marantz

model number 18	bulletin number 69-01/18-1	date
for serial numbers	to	
subject REPLACEMENT OF DIODES IN 12 VOLT SUPPLY

SERVICE BULLETIN

model number
18

FIGURE I:
MR9-054d

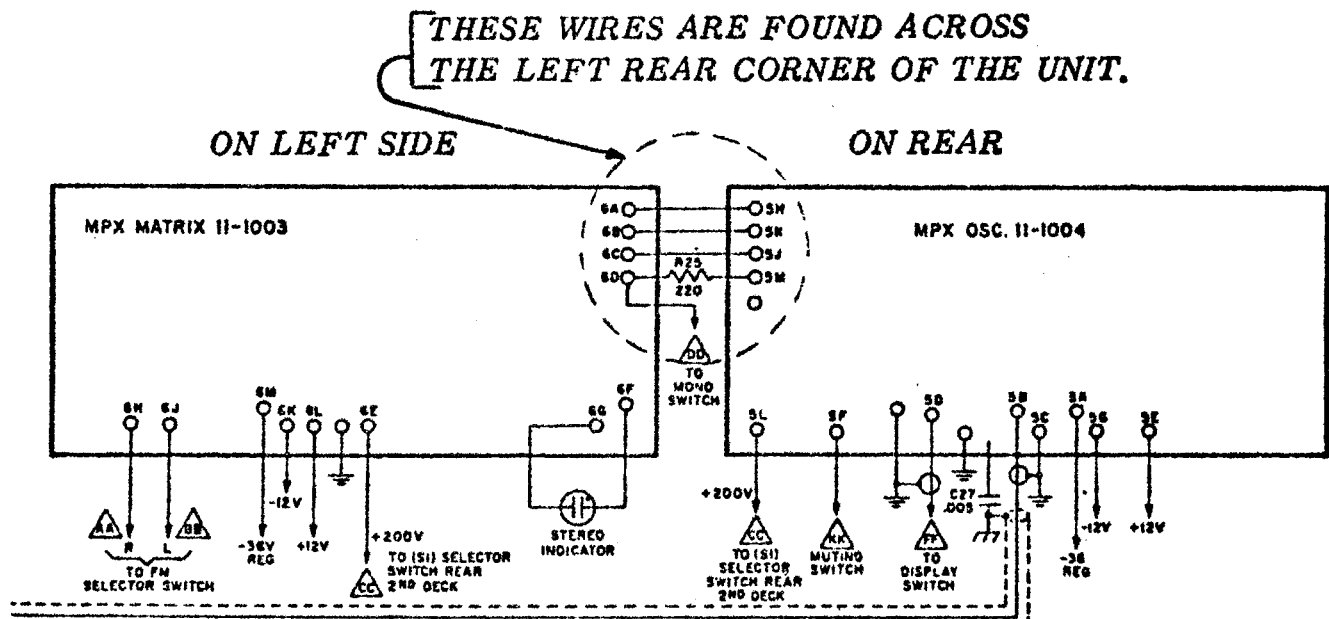
The following circuit modification is designed to correct the intermittent stereo operation in the FM mode which results from improper operation of the STEREO PHOTOSWITCH, LDR602.

1. REMOVE the three wires between the terminals of the MPX MATRIX board and the MPX OSCILLATOR board (See FIG.1). Also remove one side of resistor R-25.
2. REMOVE the two screws which secure the MPX Matrix board to the main chassis. Carefully pull the board away to expose the foil side.
3. INSTALL two insulated wire JUMPERS across both sides of the STEREO PHOTOSWITCH, LDR602 as shown in FIG.2. This effectively bypasses its operation.
4. REPLACE the matrix board on the chassis and re-solder the wires and resistor removed in step one above.

NOTE: IF THE PREVIOUS WIRES WERE SOLID, REPLACE THEM WITH STRANDED WIRE FOR GREATER FLEXIBILITY.

LIGHT CELL REPLACEMENT

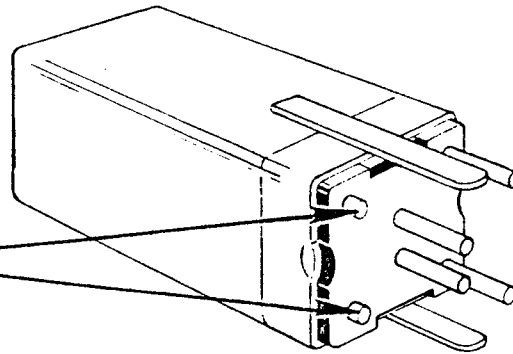
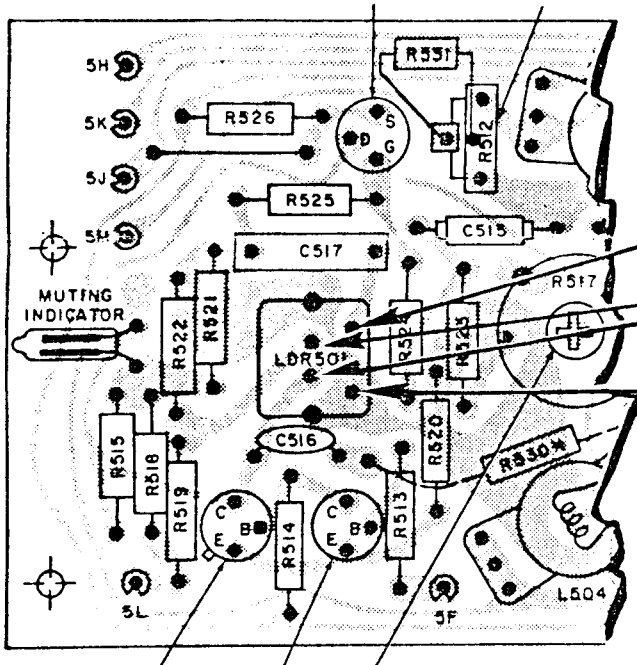
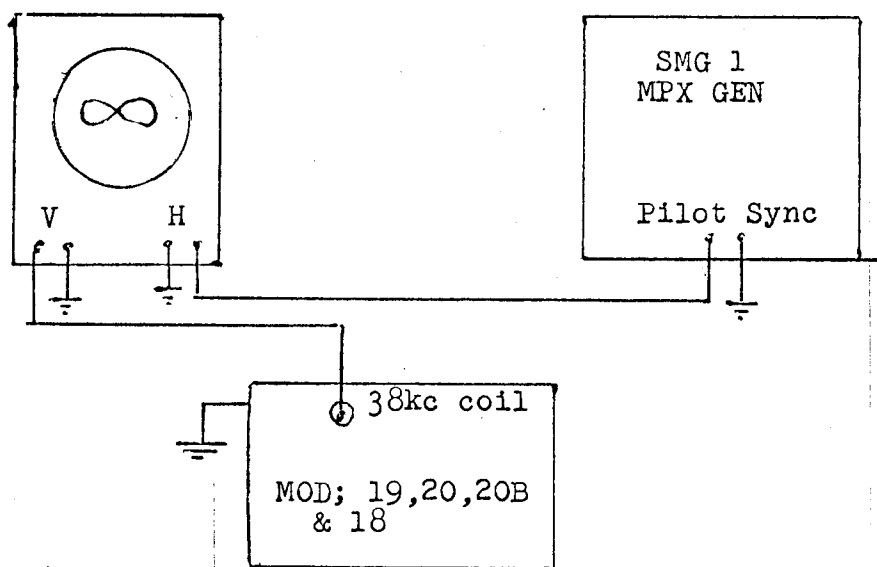
The original LIGHT CELL ASSEMBLY, Ref. Desig. LDR501, Part Number 11-1010 is no longer available and has been replaced by Part Number 331-1005-000.

Prior to installation it is necessary to modify the replacement Light Cell Assembly and the Model 18 MPX Oscillator Board as described below;

Replacement
LIGHT CELL ASSEMBLY, LDR501
P/N 331-1005-000

Cut (2) Leads

MODEL 18
MPX Oscillator Board

Enlarge PCB Holes
[to accommodate larger
lead diameter of replacement
LDR501]
